MEMORANDUM

RE: 77/79 Pine Street ZP21-0927CA ZP21-118OG

Request: Construct 9 story 49 unit
residential building on the same lot
as the Peoples United Bank.

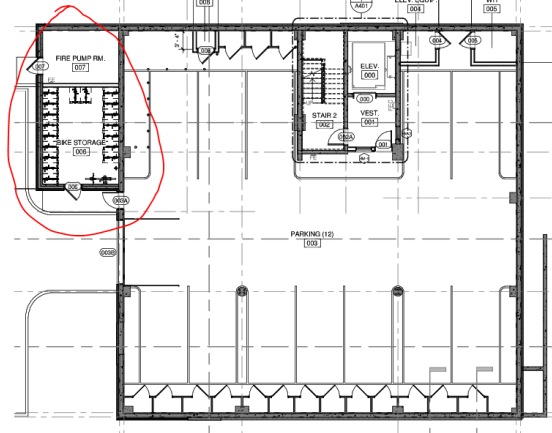
(c) *Short term bicycle parking shall be as convenient to cyclists as auto parking.*

The short term bike parking is adjacent to the vehicular parking area.

SOUTH EAST VIEW

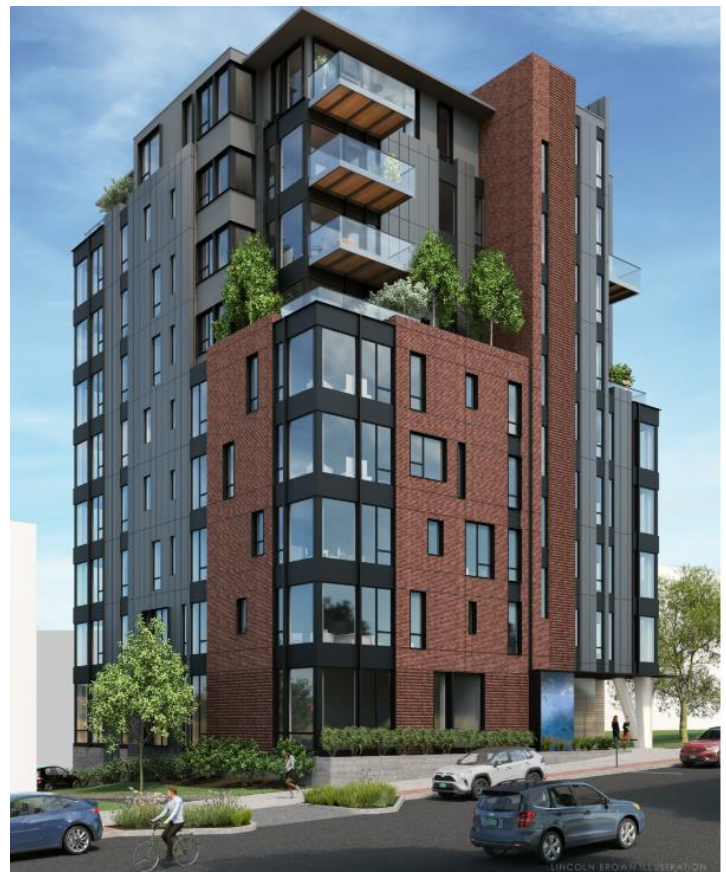
- a. The proposed building presents a design that emphasizes slender, vertically-oriented proportions to assure a rich visually interesting experience as viewed within the*

context of the downtown skyline; reinforces opportunities for establishing points of reference for visual orientation; and provides visual interest and human scale at the pedestrian level through the use of a variety of scales, materials, fenestration, massing, or other architectural design techniques;

The purposeful design (shown in a rendering, above right) utilizes materials, setbacks, architectural voids, and a vertical design to slenderize the building as experienced from the street. The particular vertical emphasis of the off-center masonry column that runs the full height of the building further emphasizes the recesses and differing heights of the bookended companion building volumes. Furthermore, the fifth story setback with green roof partnered with the three projecting balconies guides the eye upward. Vertical window ribbons further encourage skyward view. The alternating materials and varied building outline provide marked visual interest. Pedestrian level interface is excited by the conversely fluctuating recessed plane and void/solid contrast. A landscaped planter at the first level introduces the pedestrian entrance and welcomes directs to the primary access door, further identified by the modernist structural support column at the northeast corner.

The Design Advisory Board agreed that the plan is in compliance with these standards. **Affirmative finding**, if DRB concurs.

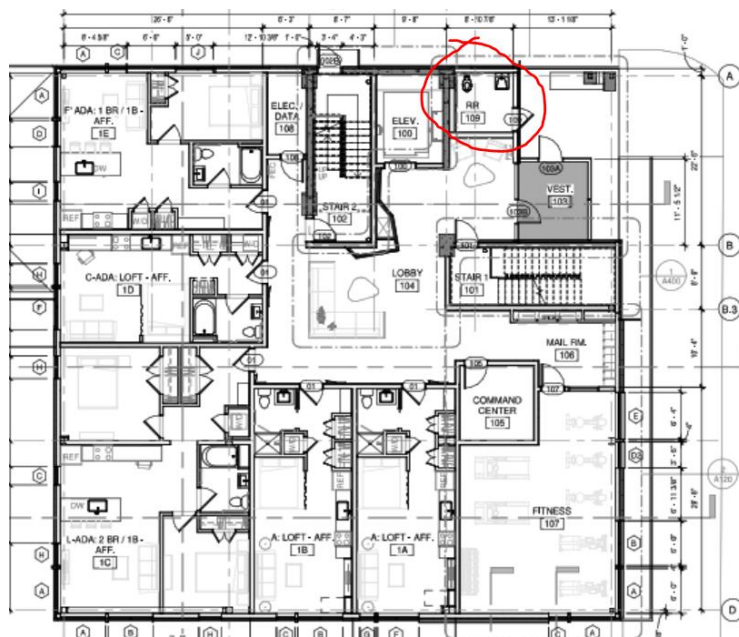
A minimum of 20 sf/1,000 sf of the gross floor area above 85 feet shall be dedicated to active and publicly accessible upper story rooftops and terraces, and/or street-level public restrooms as follows:

Floor plans confirm 4,040sf on the 9th floor establishing a gross floor area of 8466 sf above 85’.

The calculation for public space requirement is 20 sf/1,000 sf, or 20 x 4 = 48 sf. The ratio for public restrooms is 10:1, 10 x 58 (7’7” x 7’8”) = 58.06 sf. The area of the restroom exceeds the calculation defined in this standard and therefore satisfies the active public space/restroom requirement. The restroom is on the ground floor (see plan A1.01, snip on the right), exceeds the minimum size of 50 sf, must be signed from the public street, actively monitored and maintained, and open to the public during regular business hours. **Affirmative finding as conditioned.**
